VICTORY AT THE U

DESIGN RECOMMENDATION

VIRTUAL DESIGN REVIEW MEETING ON 05/10/2021

SDCI # 3036446-LU

TYPICAL TOWER PLAN (L5-20)
EDG

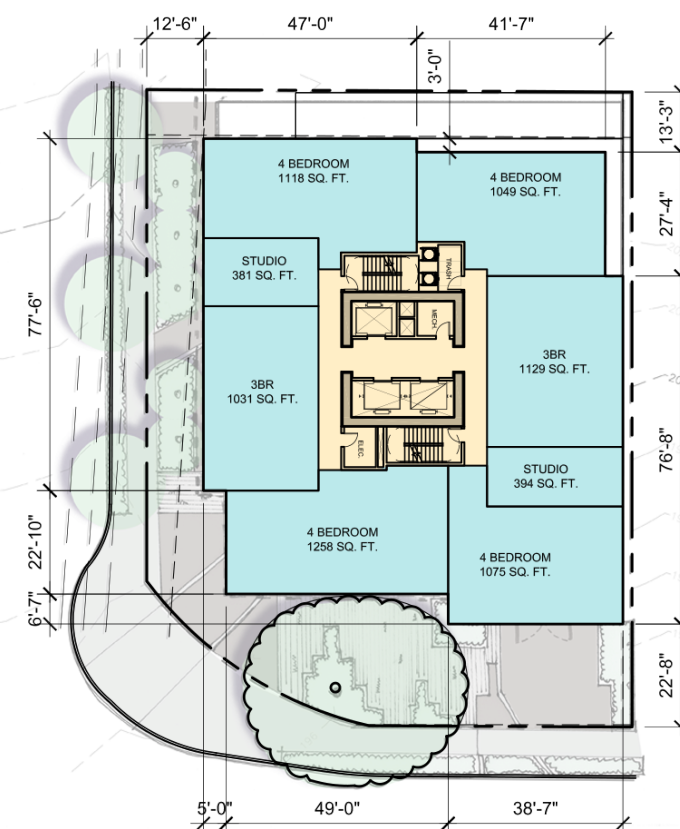
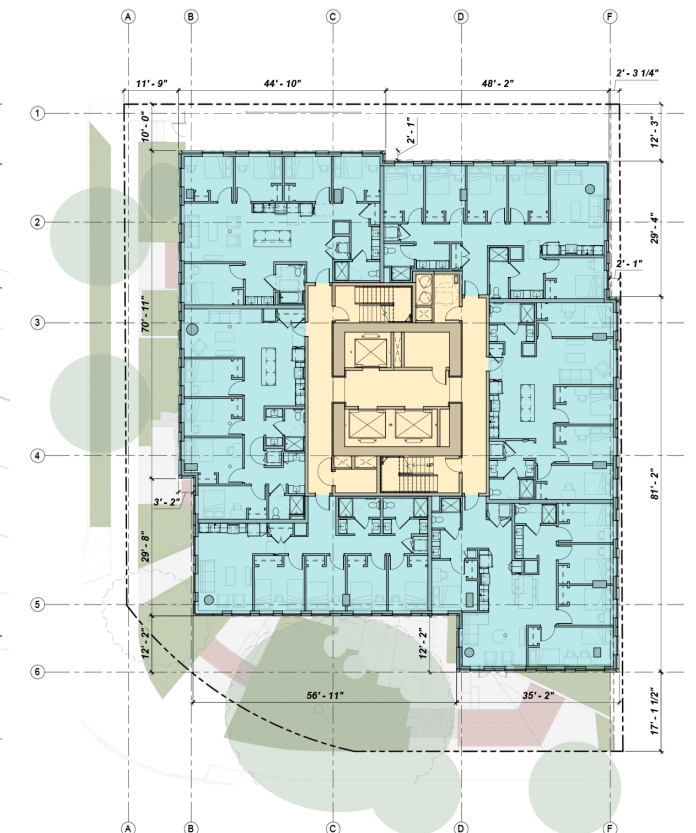
- a. The Board appreciated the thoughtful analysis and exploration of different massing options, and unanimously supported massing Option 3 for its *potential to become a strong and identifiable gateway design*, provided there is further development in response to the cultural context and additional guidance provided herein.
- b. In agreement with public comment, the Board highlighted the importance of *this site as a gateway to the University District* and specifically prioritized Design Guideline CS2-A, Location in the City and Neighborhood, and CS2-3, Gateways and Placemaking Corners

- The proposed design maintains the overall massing diagram and design approach as presented during Early Design Guidance, and explores the idea of ‘Gateway’ at multiple scales.
- At the tower scale, the modulation, impactful patterning, and coloration of the Southwest corner is a strong visual anchor at the very prominent corner defined by NE 45th St and 7th Ave NE.
- While bolder color choices might, in theory, align with a more dramatic Gateway, the design aims to incorporate colors that will be appealing and timeless.
- This feature corner is flanked by a secondary design language. These areas contrast yet compliment the corner, and maintain a strong design identity.
- The public plaza also anchors this corner and enhances the pedestrian experience, reinforcing the gateway elements of the massing above.

- Based on program and proforma evolution/goals, the tower ended up at 21 stories in height with a slightly larger typical floor plate than presented at EDG.
- Despite these minor changes, the overall massing diagram as presented in EDG has been maintained.

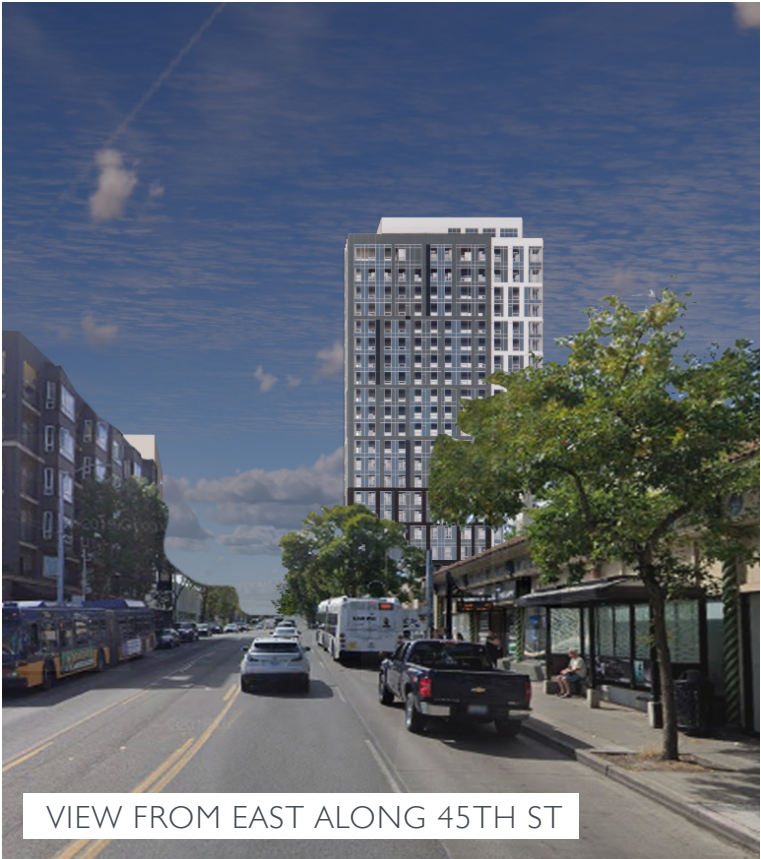
- I. Context, Concept & Massing Options
- c. As a gateway to the University District, the greater, cultural context should be manifested in the approach to design. The Board directed further study of how *the eclectic character of the neighborhood is expressed through the design*. Alternatively, if the design distinguishes itself from that character, explain why.
 - d. The Board generally supported the massing response to the immediate, adjacent context. Particularly, the transition to midrise scale to the north and the visible connection to the Blue Moon mural.

- Expressing the nature of an entire neighborhood is a delicate task. The design aims to capture the following traits identified by the Board at EDG - **URBAN, VIBRANT, ECLECTIC, AND INCLUSIVE**. These themes are incorporated at varying scales and by thoughtful facade design that is unique in comparison to other planned towers nearby.
- The Board requested that datums be incorporated into the design, albeit subtle, that reflect the strong mid-rise prevalent within the neighborhood. This is incorporated through a material change from dark masonry to the metal of the tower’s upper levels
- This change defines a subtle base that steps down from 85’ along 45th St, which has a larger scale and feel to it, down to 65’ along 7th Ave, which transitions down to a smaller scale of the neighborhood beyond.

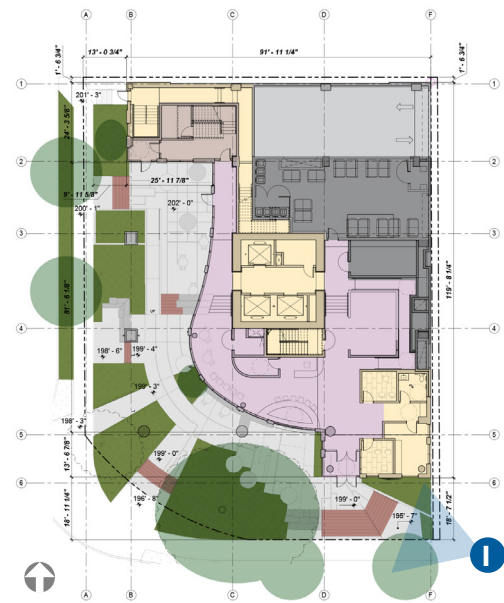
3. Ground-Level Uses & Open Space
- d. The Board supported the use of *interesting paving and inclusion of art within the open space*, and *encouraged integration of Go programming and iconography into the design*.
 - e. Considering the prominence of this gateway location and public comments regarding safety, the Board indicated *lighting is an important aspect of the design* and noted it appears to be developing in the right direction.

- Building lighting is very important to the open spaces around the building feeling safe, welcoming, and inclusive
- Landscaping lighting is used to provide ambiance
- Decorative lighting is incorporated into the branches of the Cork Oak, celebrating this large, beautiful tree and providing nice ambiance.
- Within the covered area along 7th Ave suspended lights provide a visual focus. Throughout the landscaped areas, columnar fixtures act as sculptural elements adding texture.
- Decorative paving at the Plaza reflects the Go iconography of an abstracted grid, and ‘stones’.

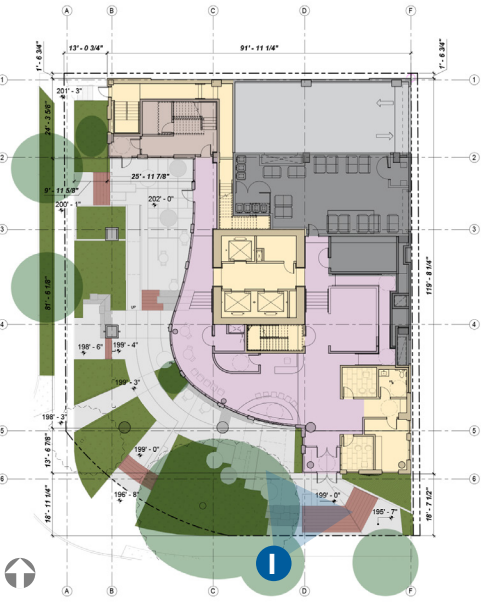
4. Landscape & Exceptional Trees
- a. The Board supported retention of the exceptional Cork Oak tree and the related departure request for bonus .5 Floor Area Ratio. The Board noted that the design of the open space should *emphasize the Cork Oak as a specimen tree*
 - b. The Board supported removal of the exceptional Strawberry tree based on the design rationale provided; however, several board members encouraged consideration of relocation of the exceptional Strawberry tree on-site.

- The Cork Oak has been incorporated as a feature within the plaza through the incorporation of feature lighting, and nearby seating so people can enjoy the tree’s foliage.
- Removing Strawberry tree is proposed - its shape (wide, dense foliage from the ground up) doesn’t fit with creating an open feel within the Plaza.
- Safety within the plaza is paramount - the design is focused on openness and good sight-lines, without concealed spaces.

CONCEPTUAL LIGHTING DESIGN

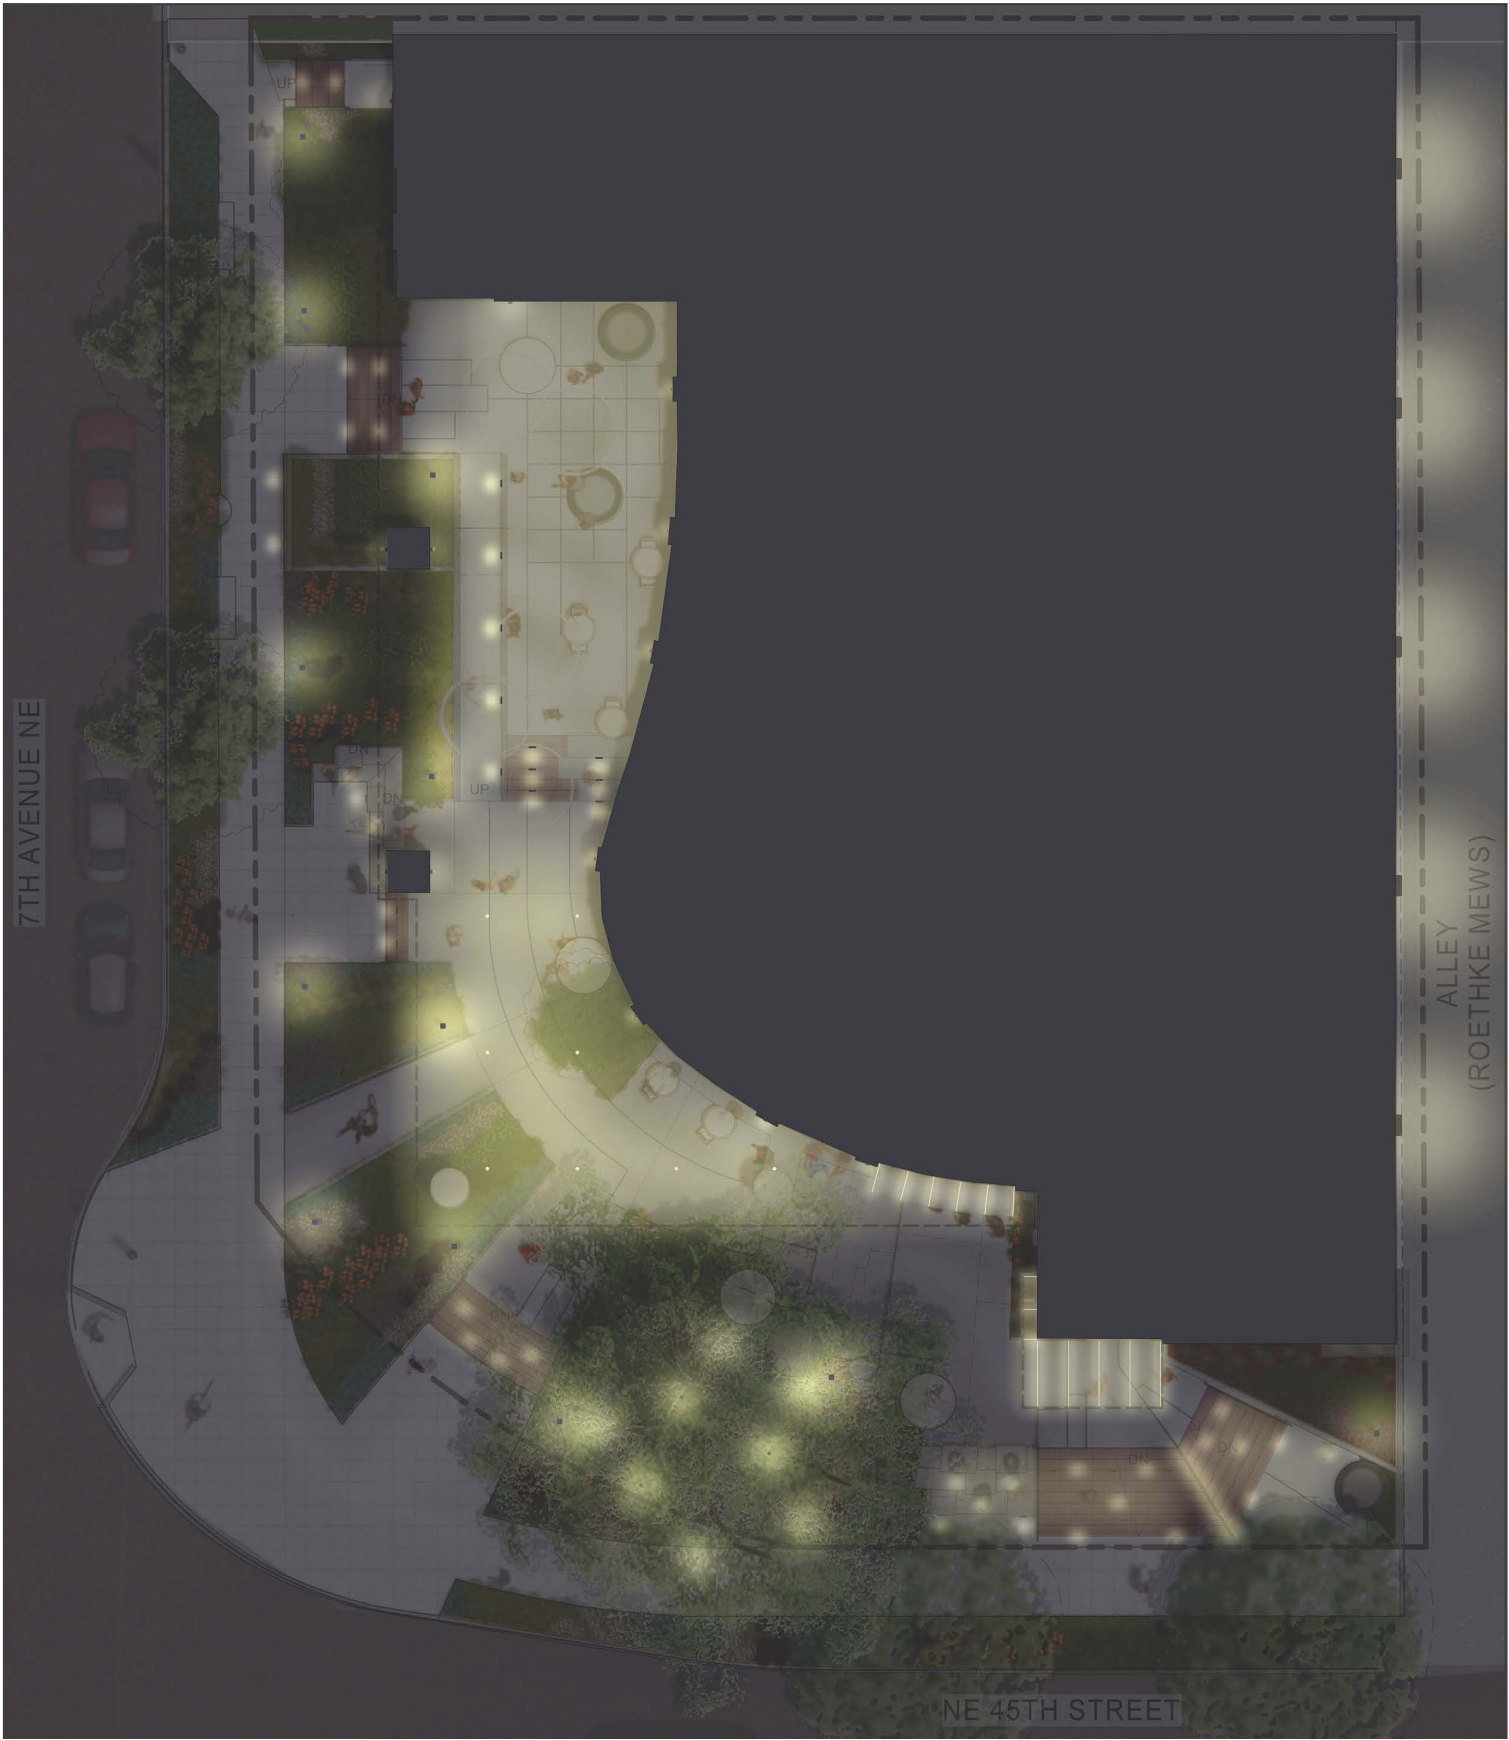
3. Ground-Level Uses & Open Space
- e. Considering the prominence of this gateway location and public comments regarding safety, the Board indicated *lighting is an important aspect of the design* and noted it appears to be developing in the right direction.

- Building lighting is very important to the open spaces around the building feeling safe, welcoming, and inclusive
- General illumination is provided with recessed down lights, step lights, linear canopy fixtures, and columnar bollards.
- Accent lighting (wall sconces, direct/indirect wall lights) work with the architecture to provide visual interest and texture.
- Feature lights (suspended fixtures in covered plaza, Cork Oak pendants, column lights) offer a blend of lighting and sculpture to animate the Gateway Plaza.
